100 MAYFIELD PROJECT

FINAL EIR

Response to Comments and Text Revisions to the Draft EIR

LEAD AGENCY:
City of Mountain View
Community Development Department
500 Castro Street
Post Office Box 7540
Mountain View, California 94039-7540

FIGURE 4.8-3a

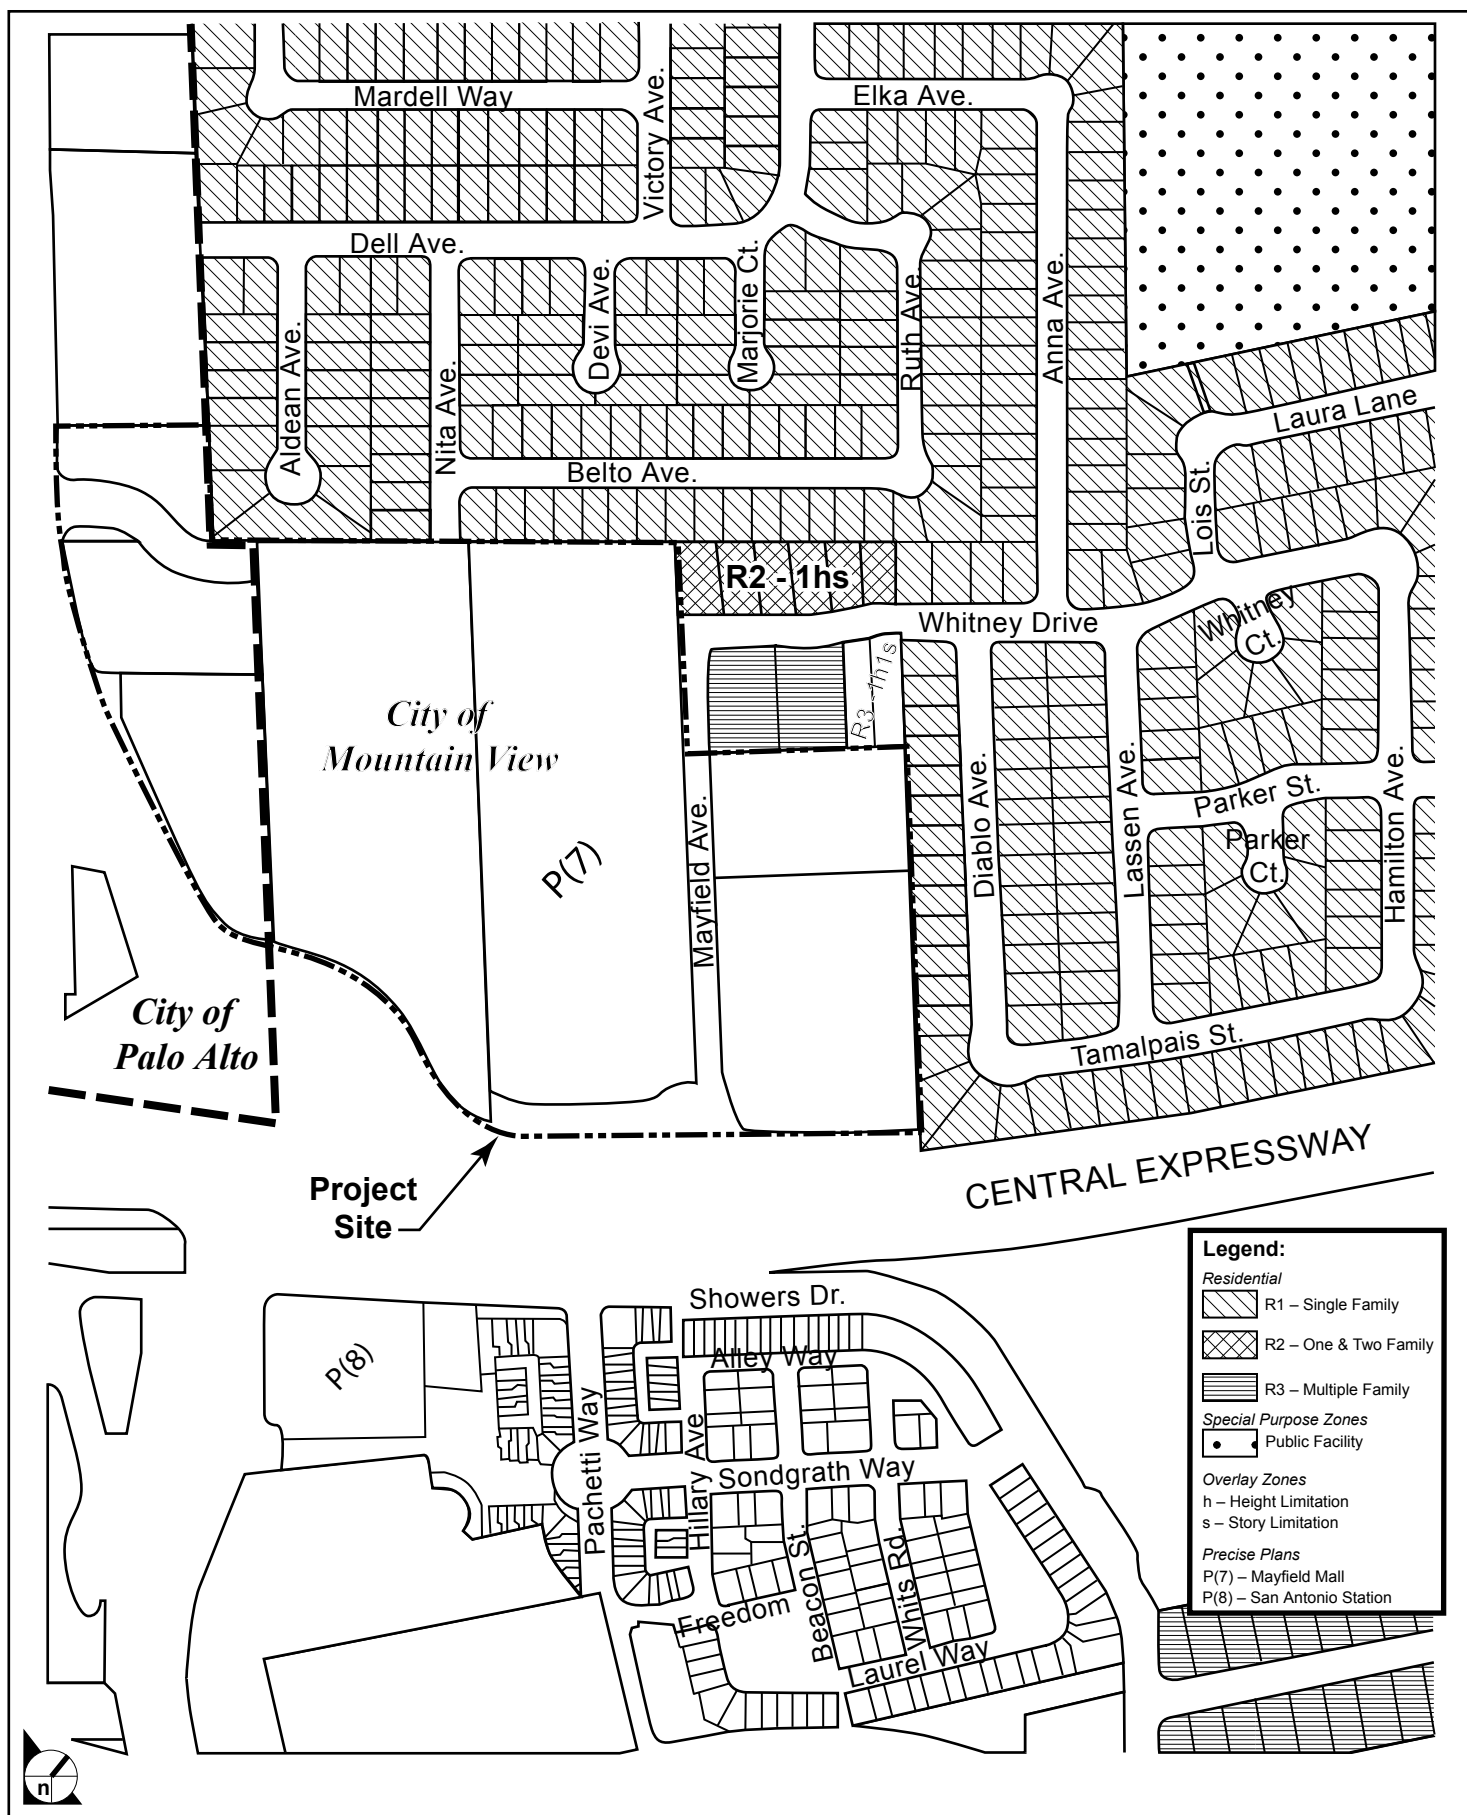
Commenters noted that, **Figure 4.8-3a, Existing Zoning—Mountain View**, should be corrected to indicate that the parcels on the north side of Whitney Drive that are zoned R2 also have a single-story overlay zone. The figure has been revised and is provided in **Chapter 5.0** of this document. The properties fronting on Diablo Drive are zoned R1 which allows two stories. It would be inequitable to place a single-story overlay on the Project site if there is no single-story overlay on the properties fronting on Diablo Drive. The proposed Project would also have a maximum height limit of two stories and is not “exempt” from height requirements.

Figure 4.8-3a, the residential designation for parcels along Whitney Drive east of Diablo Avenue has been revised to include the single-family overlay.

FIGURE 4.12-4a

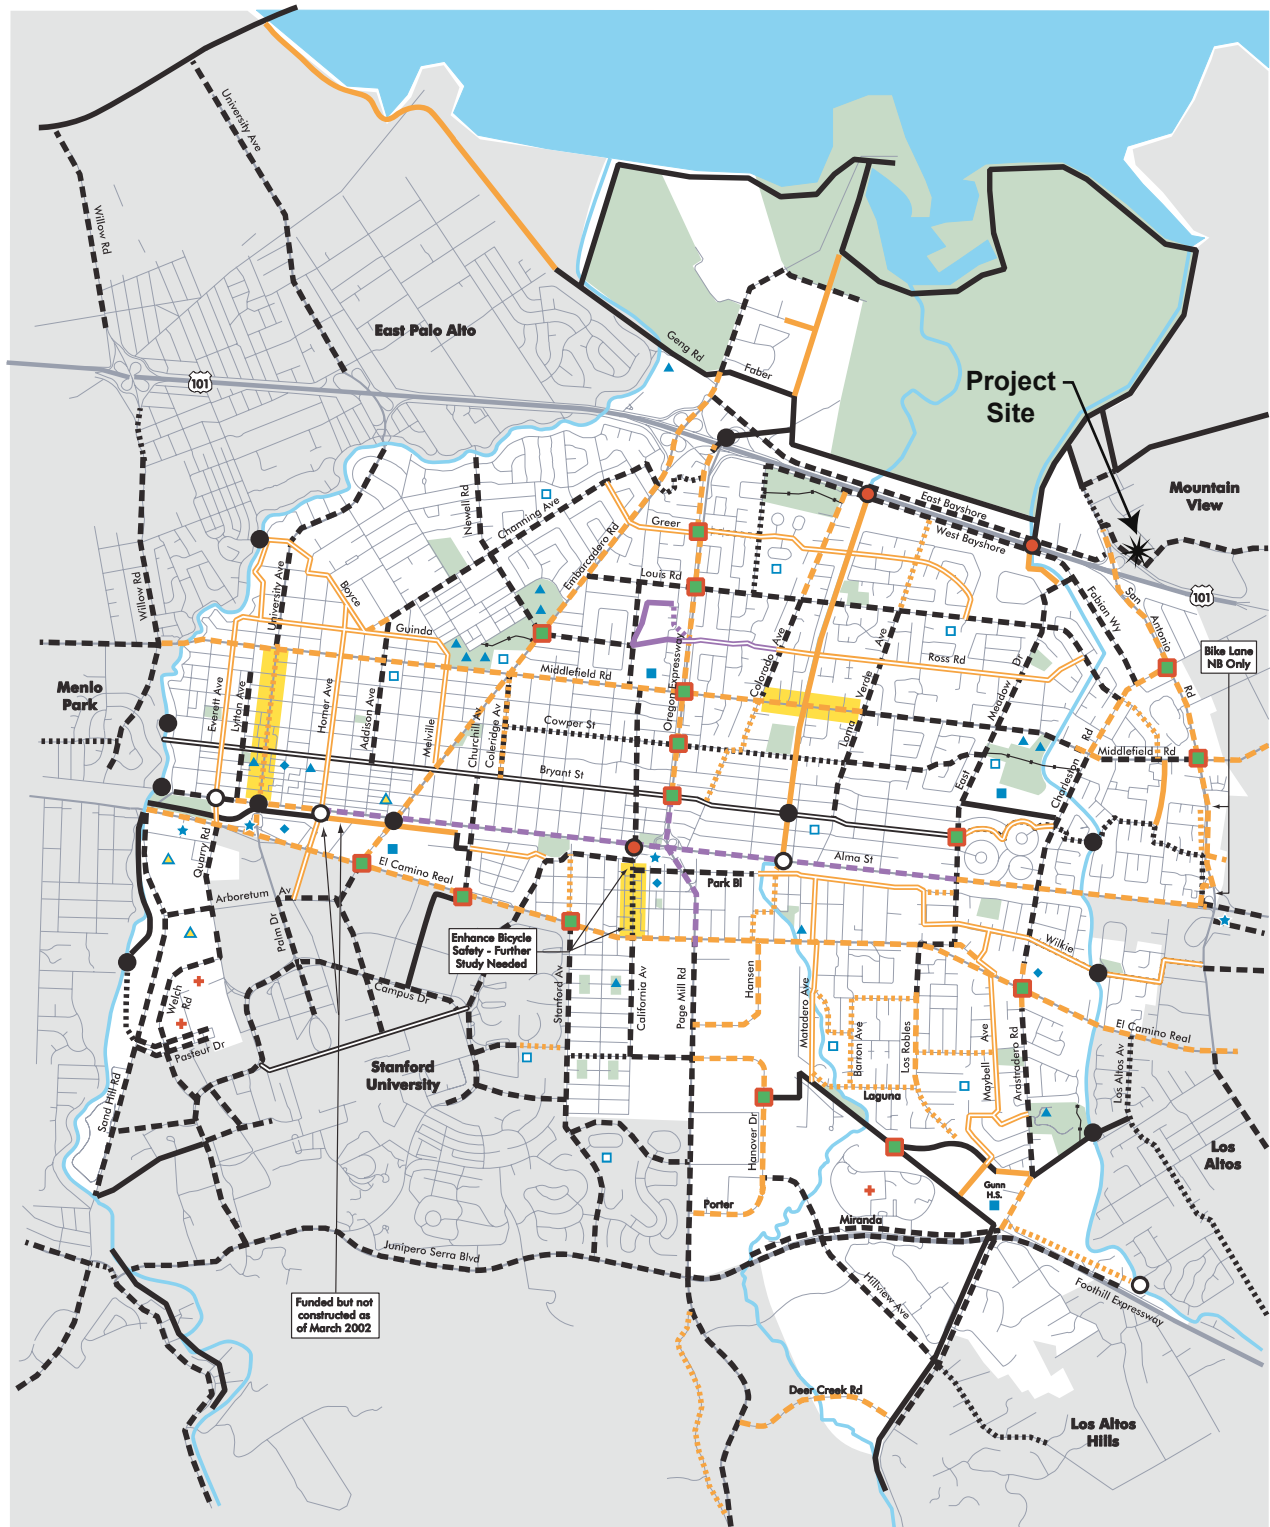
Several commenters submitted comments that the Pedestrian and Bicycle Facilities section on pages 4.12-7 and 4.12-8 needed to include a description of the identified issues associated with pedestrian and cyclist crossing of Alma Street. **Figure 4.12-4** does not show future bike routes within the City of Palo Alto. For example, the bike boulevard along Wilkie Way is expected to be established in 2006 (i.e. near term).

Figure 4.12-4a has been added to show the recommended future bicycle network in the City of Palo Alto.

FIGURE 4.12-6

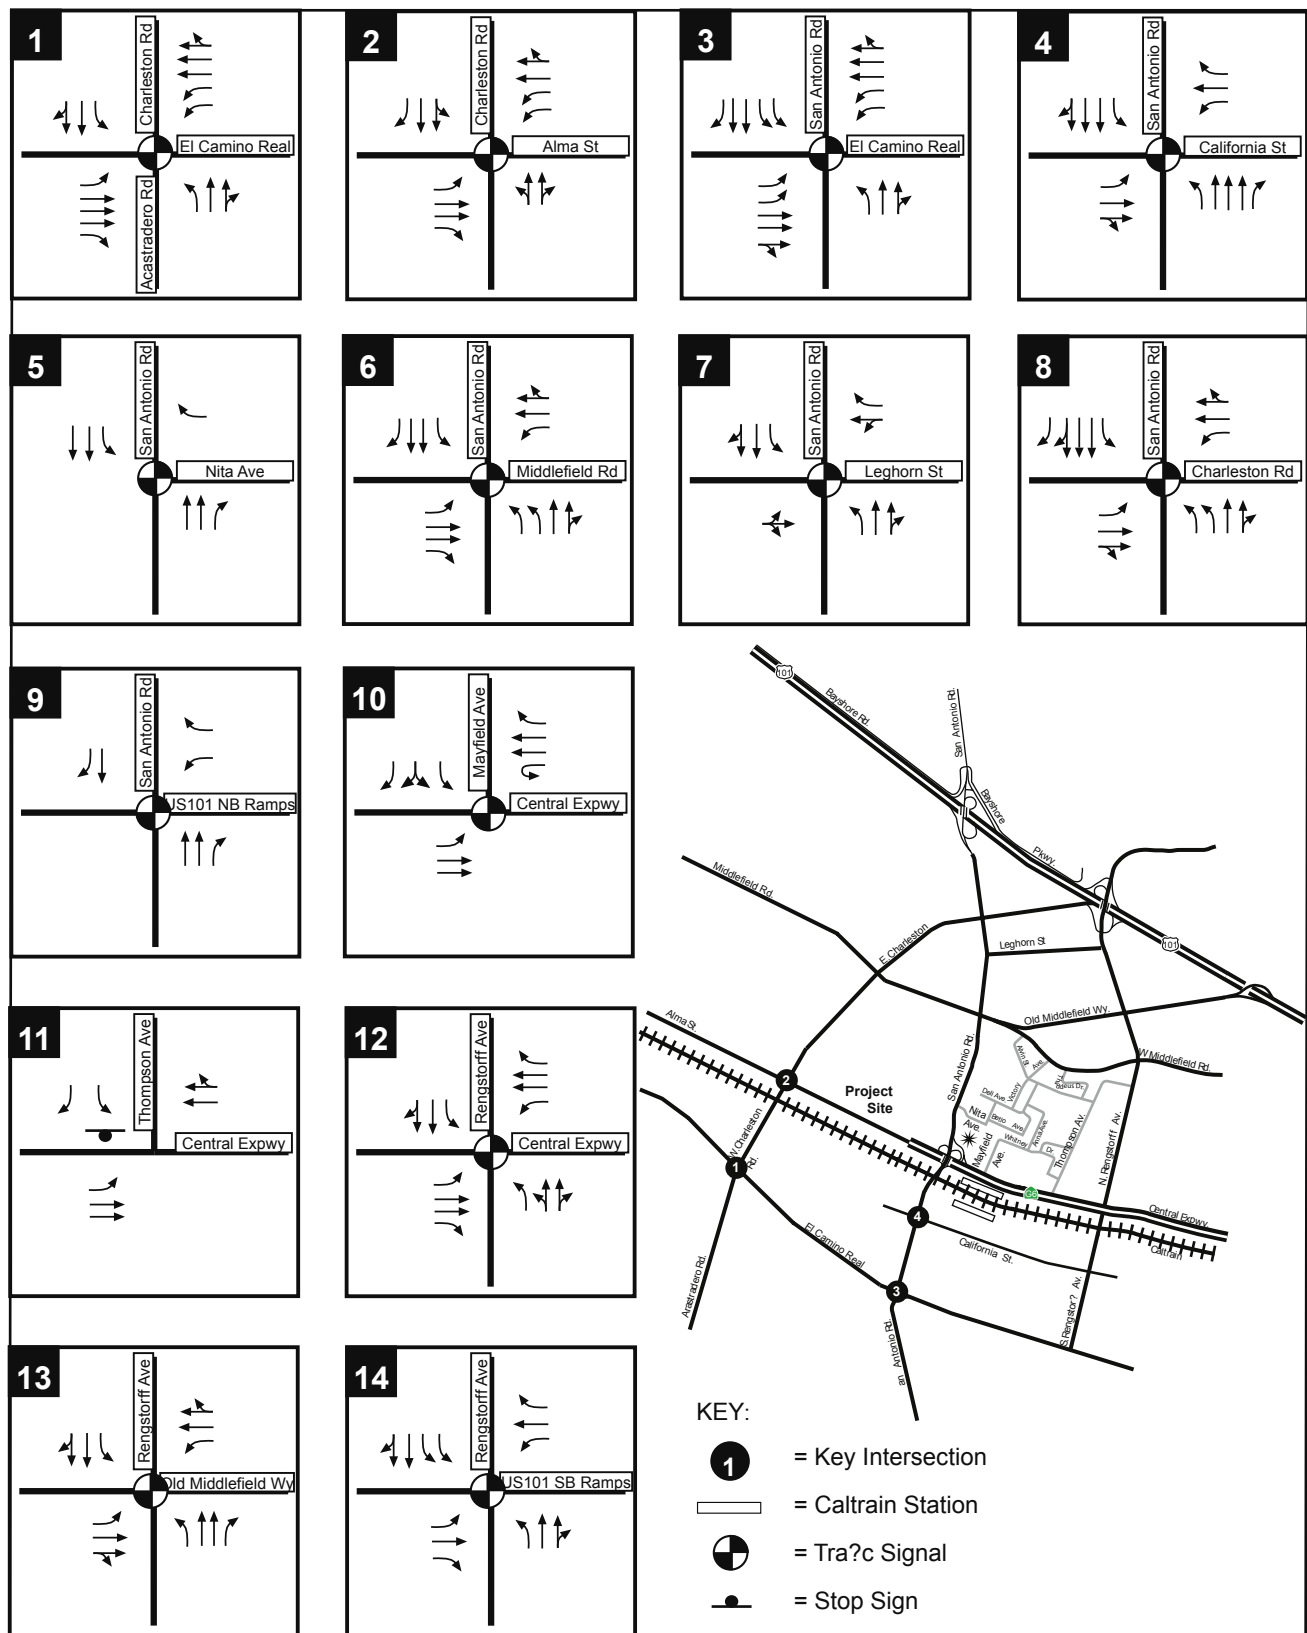
Several commenters requested that lane configurations at the Palo Alto intersections shown on **Figure 4.12-6** be double-checked. For example, the westbound approach on San Antonio Road (southbound in the report) at Charleston Road contains one left-turn lane, two through lanes, one shared through/right-turn lane, and one right-turn lane; there are no two exclusive right-turn lanes on this approach. It is realized that data entry in the Traffix software would be somewhat different to reflect the volume entering the frontage road. [Caporgno (64g); Rosewalk Homeowners Association (36a, EPC1-7); Greenmeadow (37q)]

For westbound San Antonio Road traffic at Charleston, vehicles in the shared-through right lane are destined for the frontage road. This right/through lane was coded as a right-turn lane and not a shared lane in Traffix because the shared lane would provide additional capacity to the other westbound through vehicles that are not entering the frontage road and would result in a better level of service. Therefore, a more conservative assumption was used in the Draft EIR. **Figure 4.12-6** has been updated to show the shared through/right lane. The revised figure is provided in **Chapter 5.0** of this document. The correction to the figure does not result in any changes to the analyses or conclusions.

Figure 4.12-6, which shows existing intersection lane configurations, has been revised to correctly show a shared through/right lane at the intersection of westbound San Antonio Road and Charleston Road.

FIGURE 4.12-7

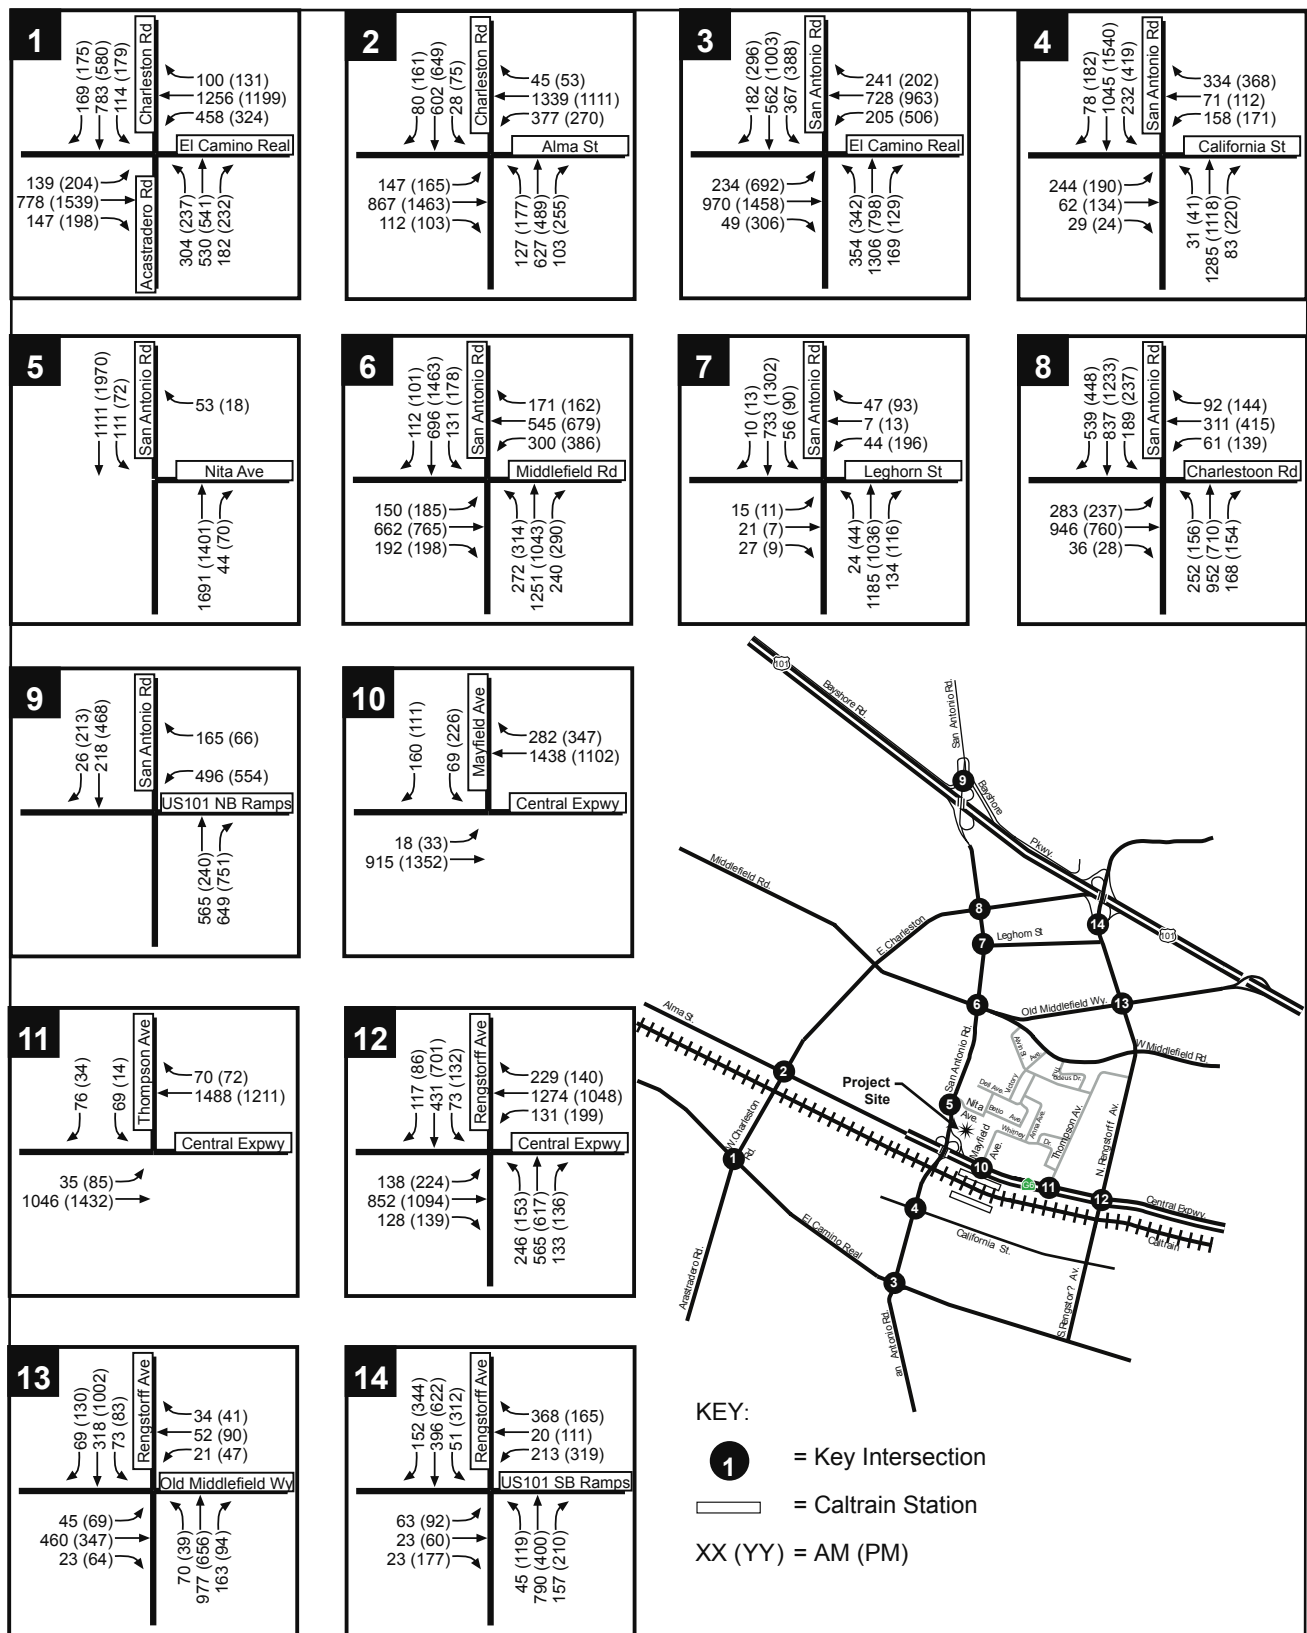
The volumes in **Table 4.12-13** do not correspond to the volumes presented on **Figure 4.12-15**. The table lists 90 added trips to Victory and the figure shows 130 trips. The EIR should contain all collected data related to neighborhood volumes. [Caporgno (64n); Greenmeadow (37u); Reid (18b, EPC2-5)]

The volume figures for Background Conditions and Project Conditions (with Current and Amended Plan) have been checked. Please see **Chapter 5.0** for the revised **Figures 4.12-7, 10, and 13** reflecting corrections. Some of the volume imbalances can be attributed to counts conducted in different years or counts conducted with different peak-hour start times. The volume figure corrections do not result in any change to the findings or the analyses.

Figures 4.12-7 and **4.12-13** have been revised to show correct traffic volumes, in accordance with the text in the Transportation section of the EIR.
